ADDENDUM #2
IFB #15-30
BUTLER CONCRETE PROJECT

CONCRETE SIDEWALK REPAIRS
BUTLER MIDDLE SCHOOL
LOWELL PUBLIC SCHOOLS
CONSTRUCTION PLAN

C-101

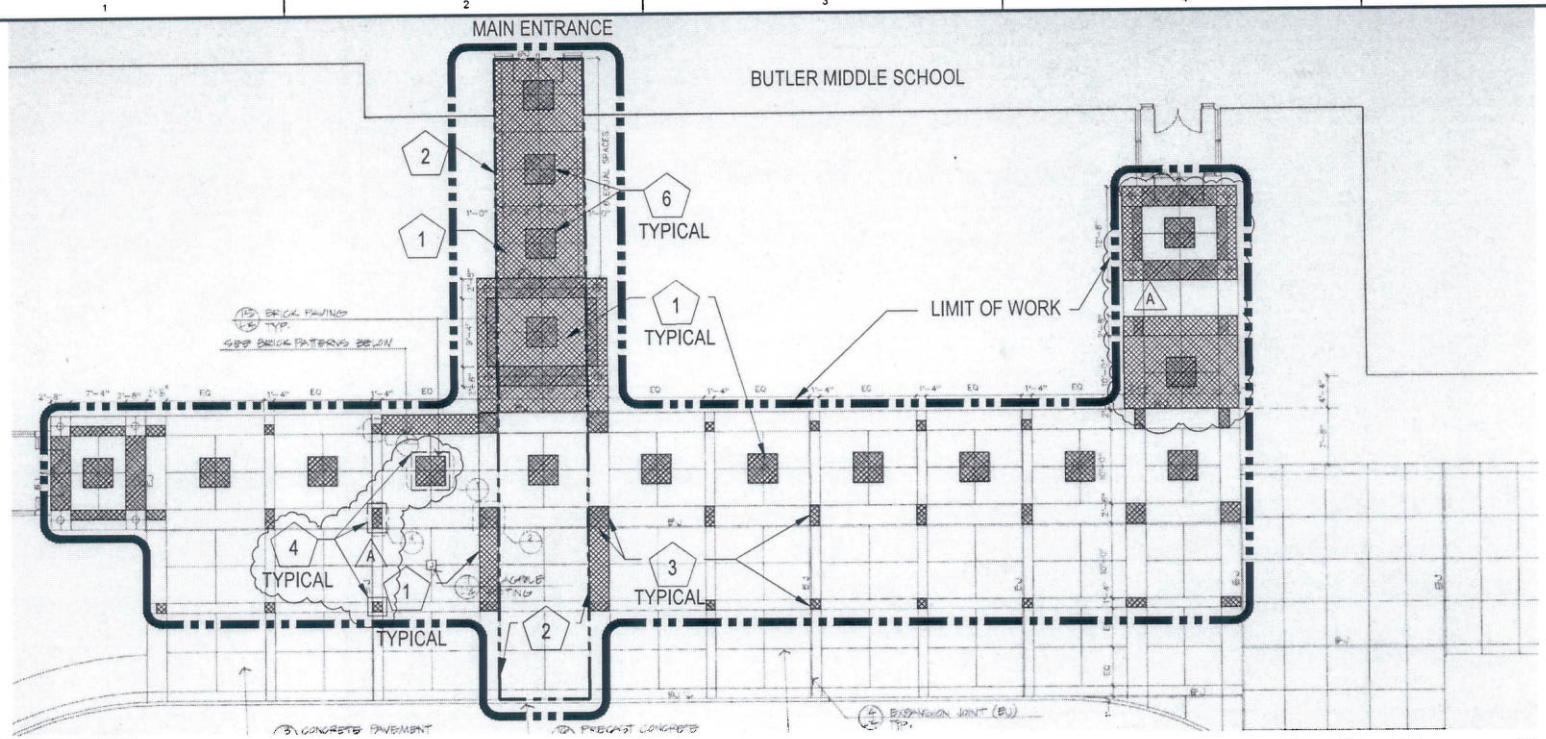
- See cloud plan revisions on C-101 (Sawcut panels adjacent to panels scheduled for removal to uniform aligned edge. Remove concrete around all canopy columns.)

4 A. AT ALL LOCATIONS WHERE PANELS OR PAVERS ARE SCHEDULED YO BE REPLACED, SPALLED OR DAMAGED ADJACENT PANELS SHALL BE SAWCUT IN A UNIFORM PATTERN THAT ALIGNS THE OUTSIDE EDGES OF ALL NEW CONCRETE INFILL WORK.
